MANUAL CHANGES

Model Number: 8690B-H26
Date Printed: March 1969
Part Number: 08690-91004

Figure 1. Model H26-8690B Rear View (Part of Change 1)

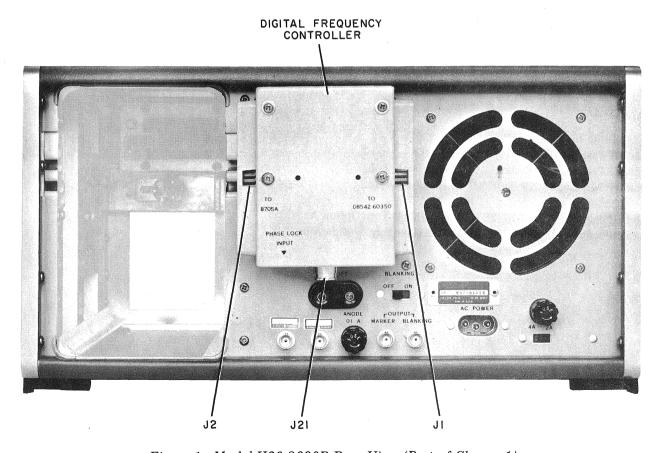
Page 1, Figure 1:

Replace figure in manual with attached Figure 1.

Page 3 of this Change Sheet, Figure 1:

Add a BNC connector to the left of the SWEEP connector. Label the new connector TUN VOLTAGE. The connector transmits the tuning voltage to the 85405A Control Unit in the 8543A Automatic Network Analyzer.
